ADDENDUM NO. 2

DATE: February 24, 2023

RE: Dickinson Park Sports Fields Renovations
Project No.: 21-1558

Drawings: (all revisions have been clouded and tagged with a delta-2)

PROJECT: **TOPOGRAPHIC SURVEY**

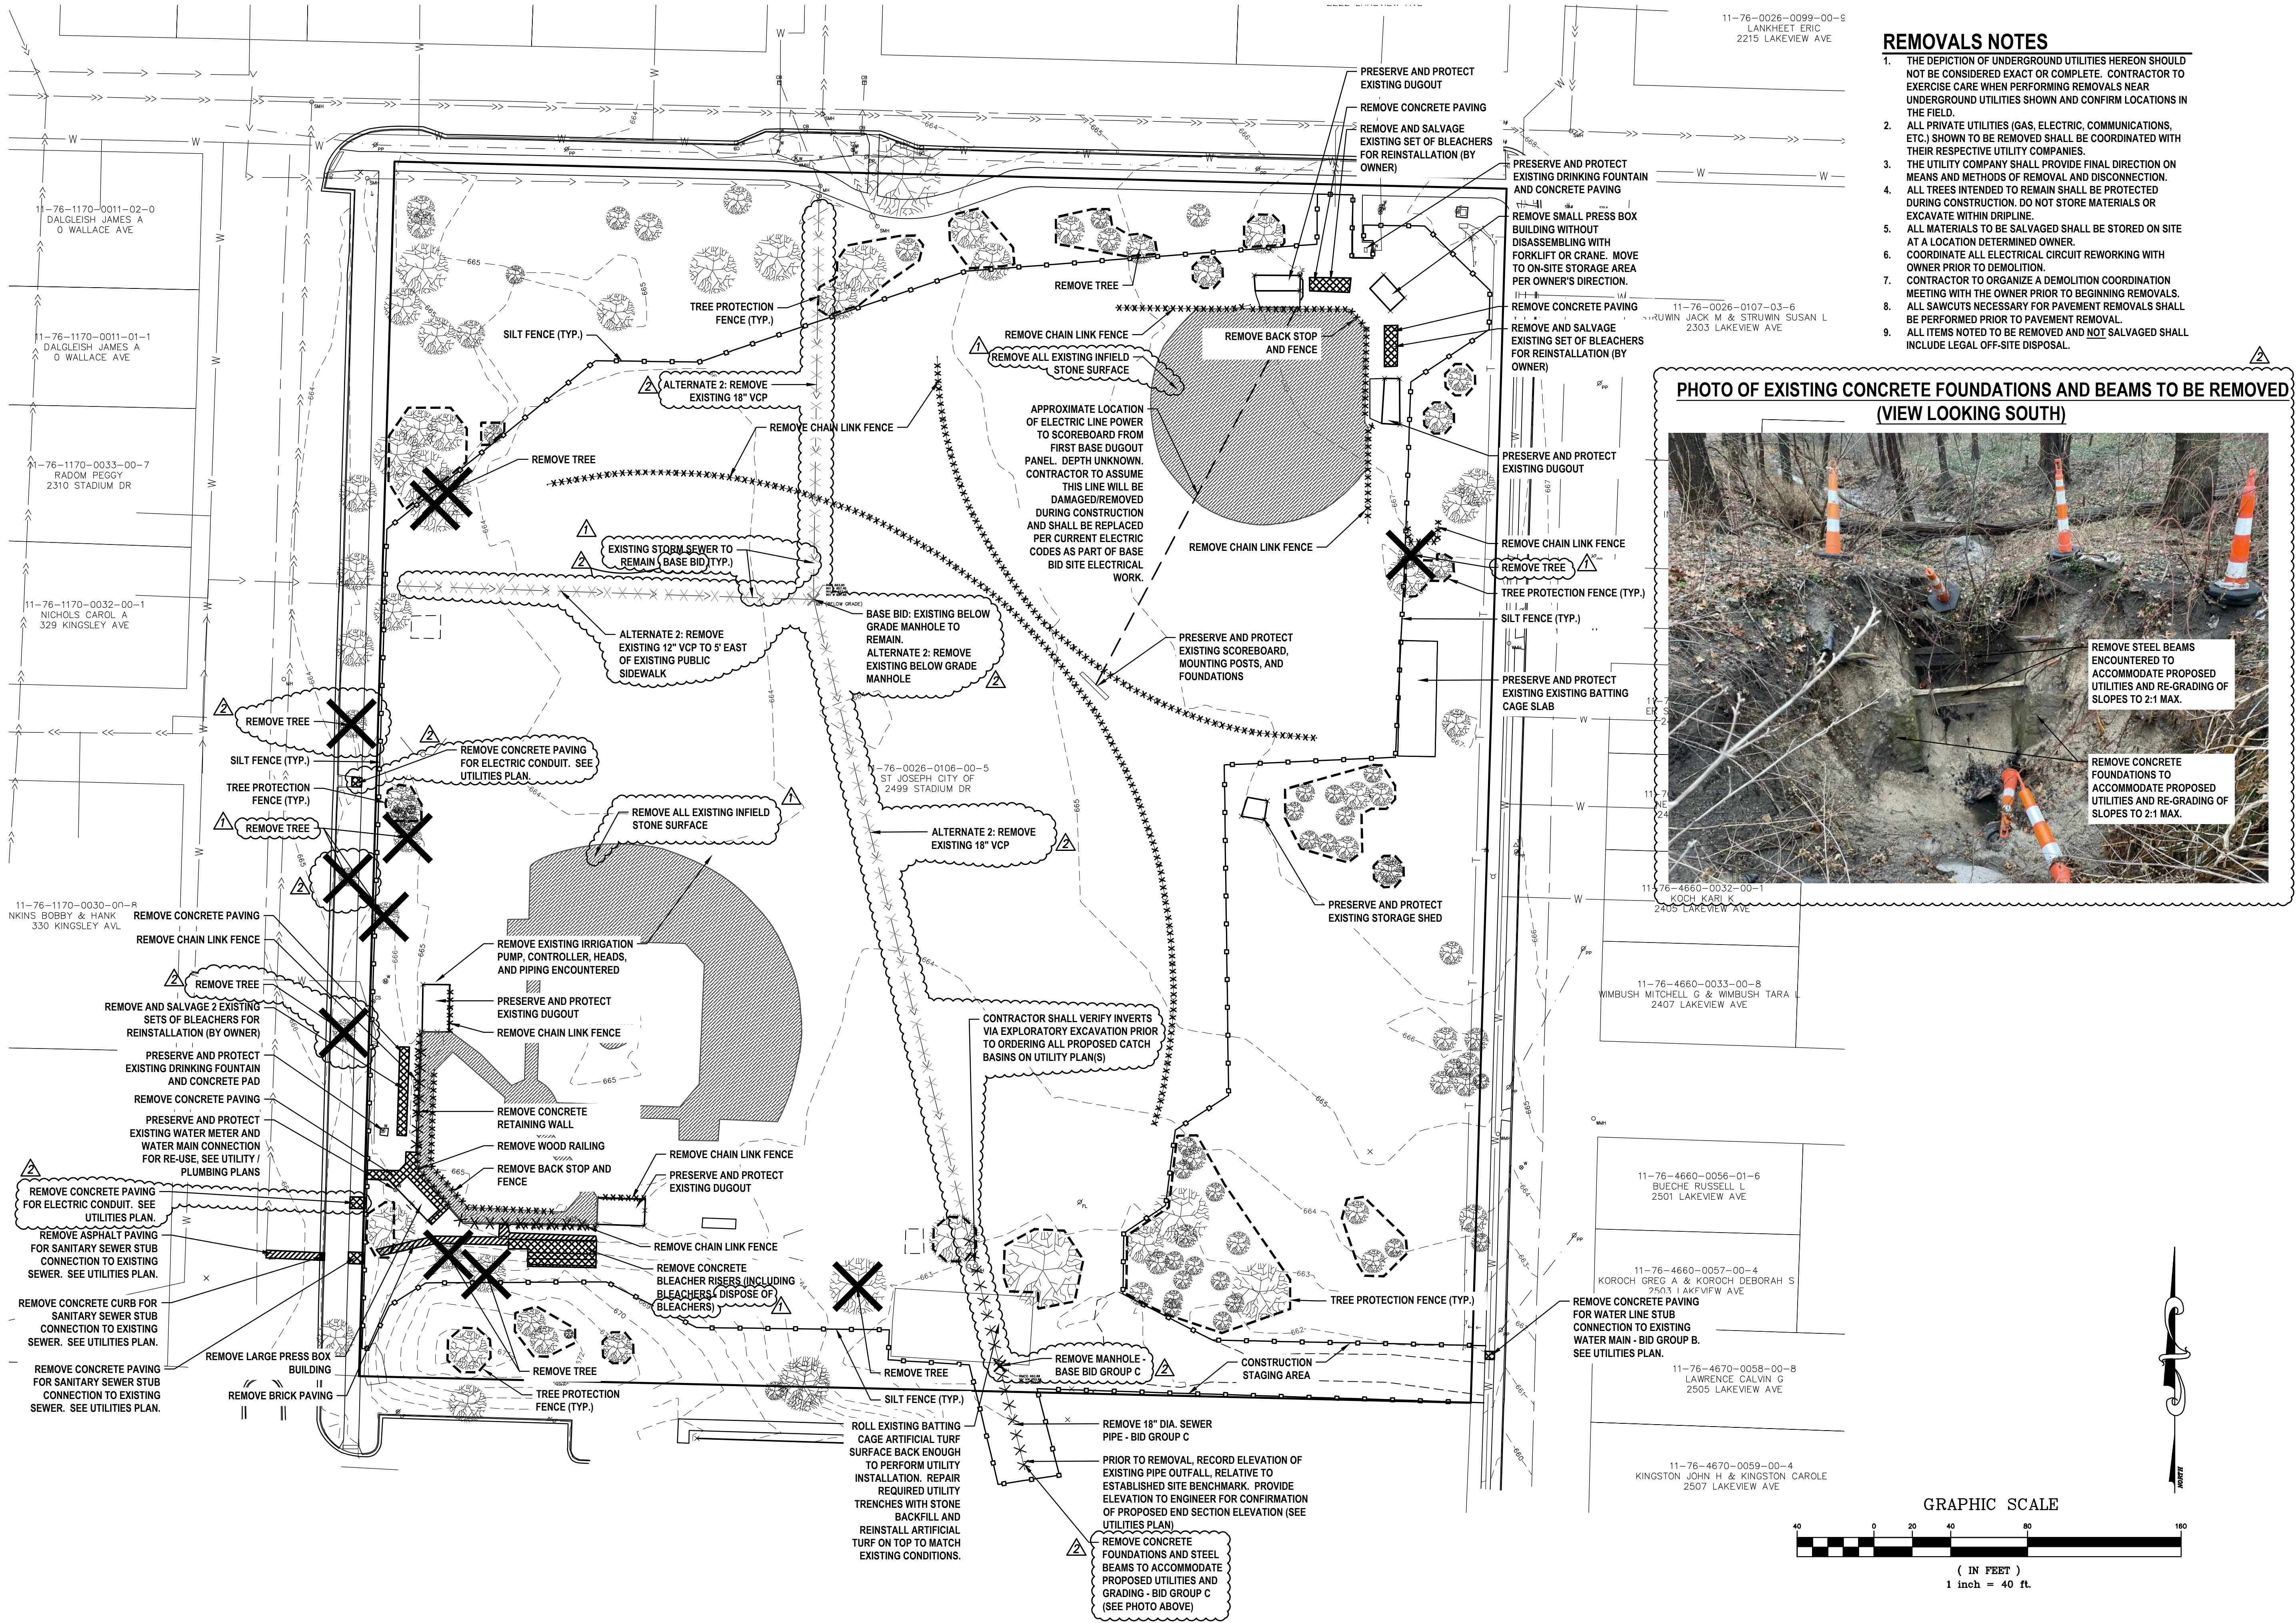
- b. Add Sheet S2.1 – Structural Details to Sheet Index.
 - c. Add Sheet E1.2 – Electrical Power to Sheet Index.
3. Sheet 2 - Topographic Survey
 - a. Revise route of existing 12" VCP pipe in leftfield of the baseball field.

- b. Add location of below grade manhole in leftfield of the baseball field.
4. Sheet 3 – Removals Plan
 - a. Add three additional tree removals.
 - b. Add concrete removal for electric conduit installation.

PHOTO OF EXISTING CONCRETE FOUNDATIONS AND BEAMS TO BE REMOVED (VIEW LOOKING SOUTH)

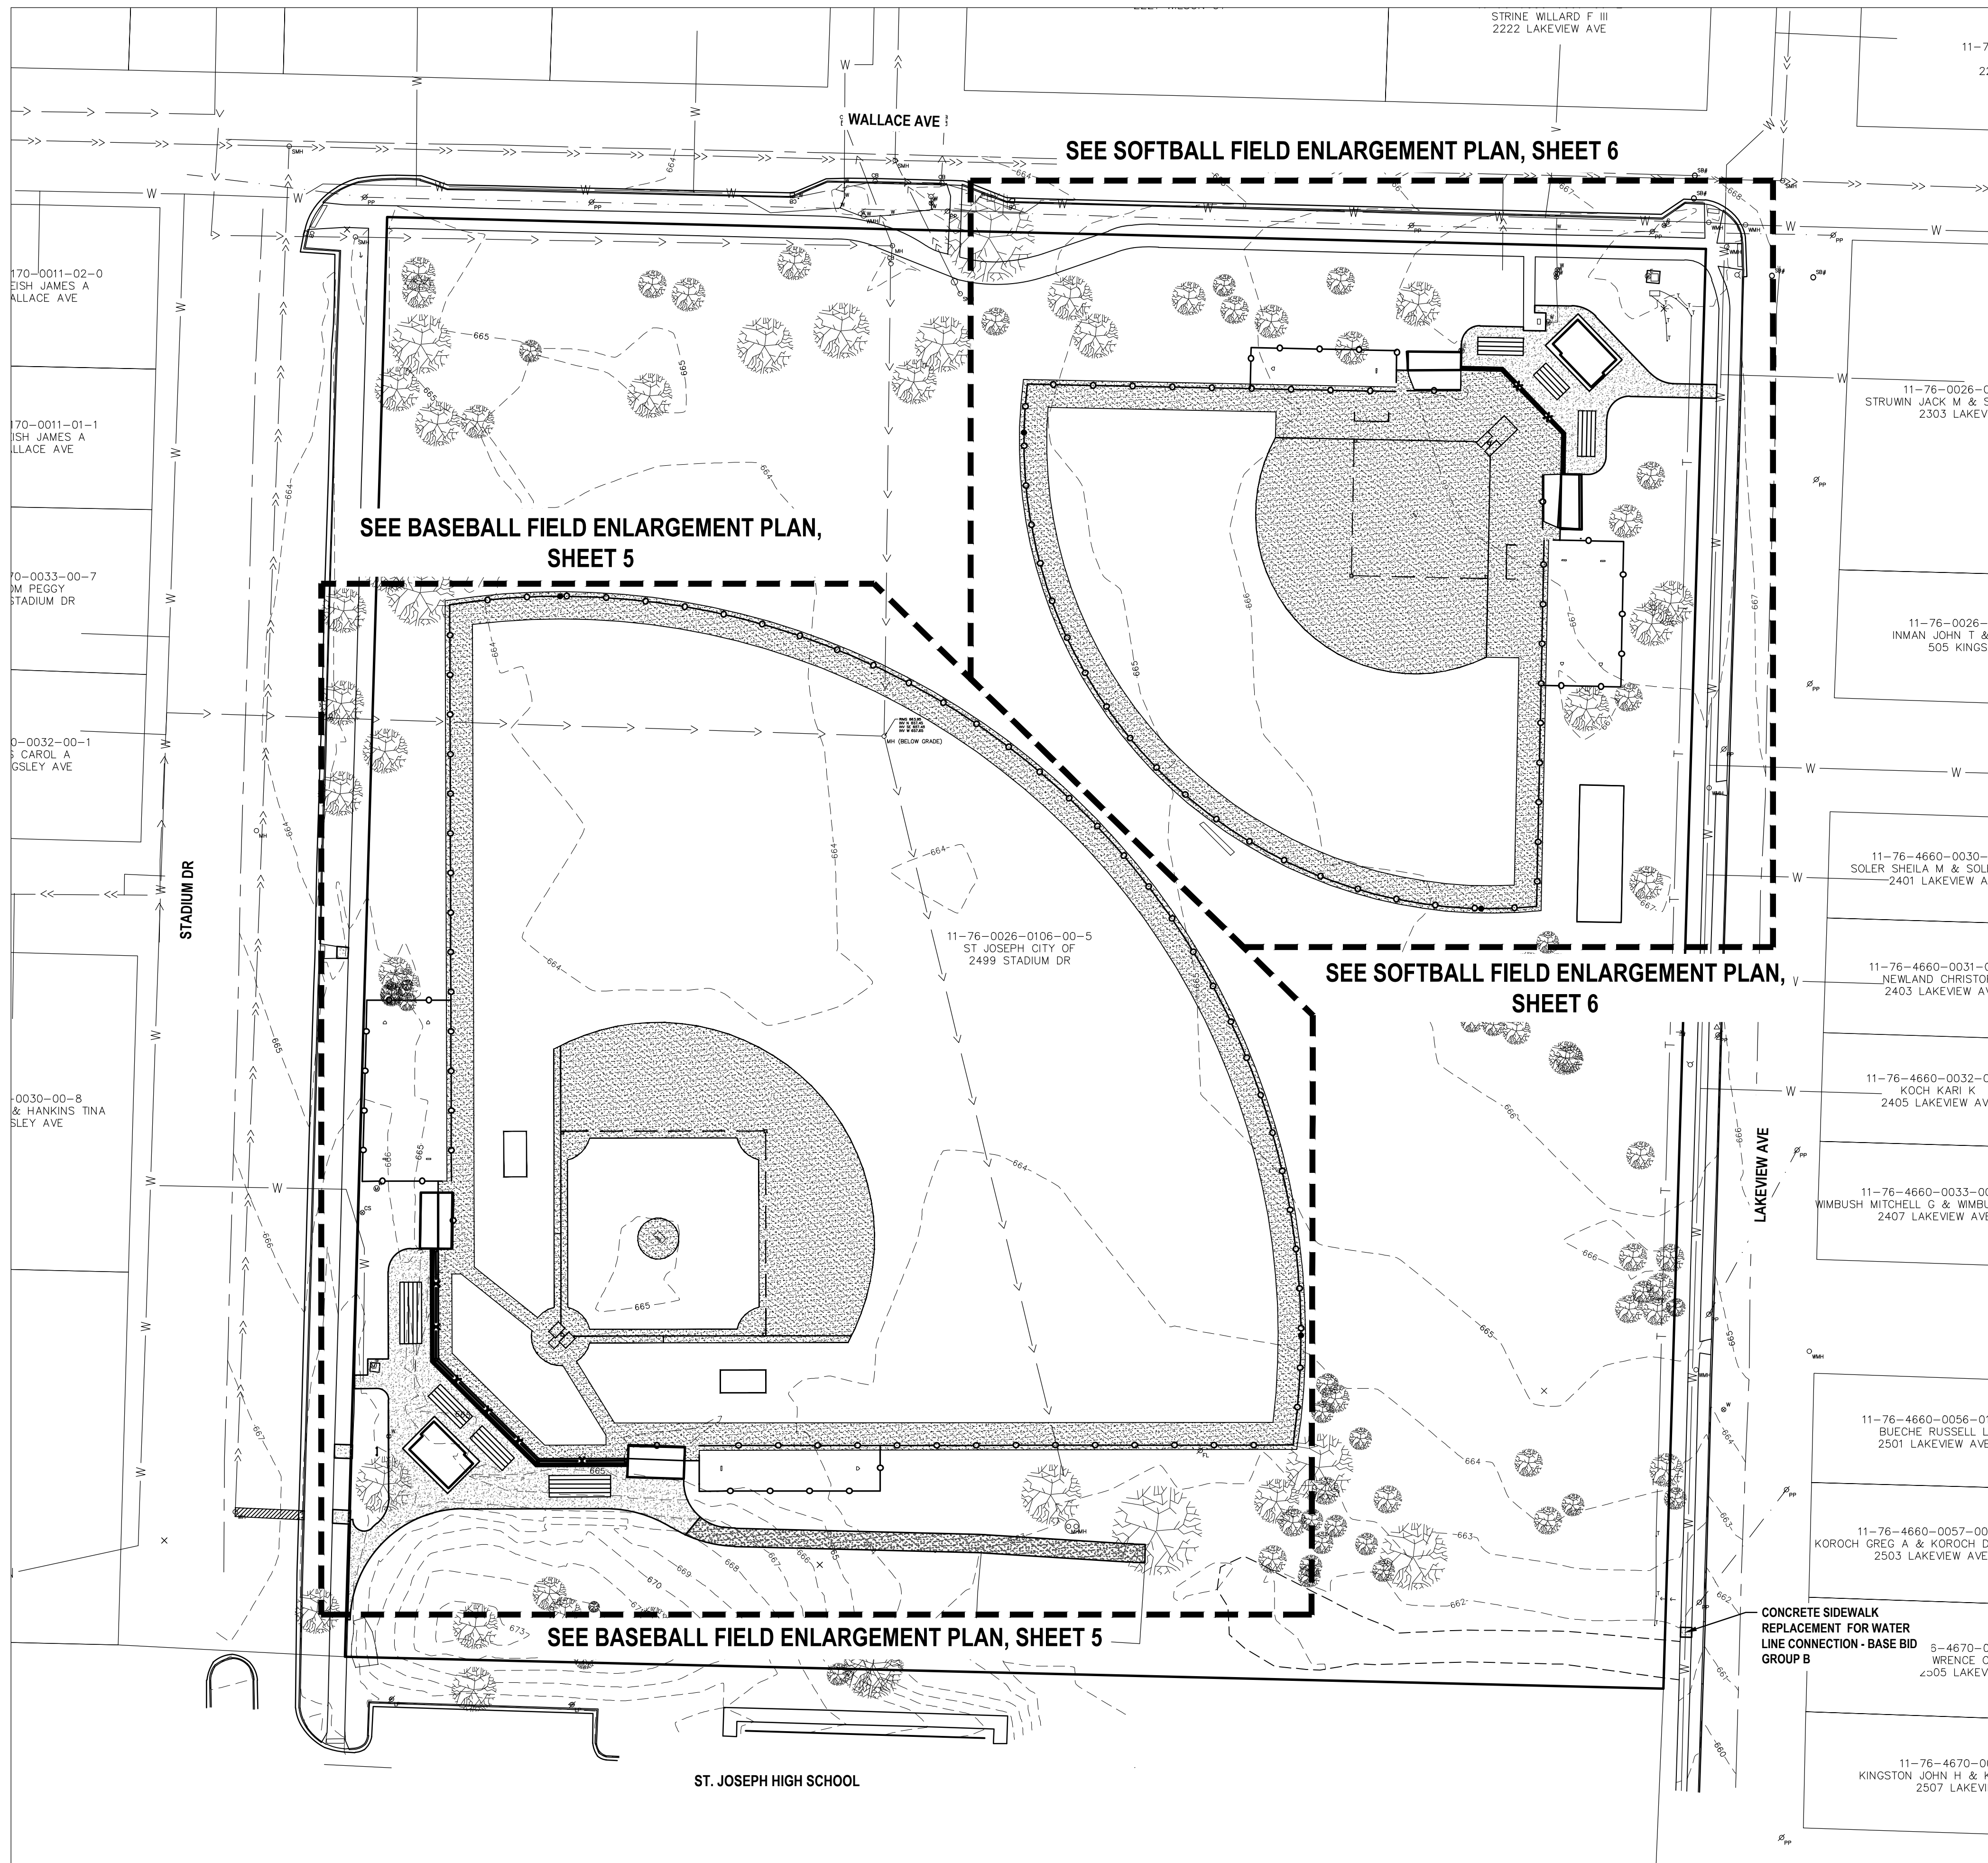
- c. Add notes specifying existing storm sewer pipes and below grade manhole to remain as part of base bid, but to be removed as part of Alternate 2.
 - d. Revise length of 18" dia. sewer pipe to be removed south of storm water quality unit located north of the baseball field batting cages.

- e. Add note to remove manhole south of existing baseball field batting cages.
 - f. Revise note to remove concrete foundation and steel beams to accommodate proposed utilities and grading.

- g. Add photo of existing concrete foundation and steel beams to be removed.
 - h. Add note to verify inverts via exploratory excavation prior to ordering all proposed catch basins on utility plan(s) regarding existing storm water quality structure north of existing baseball field batting cages.
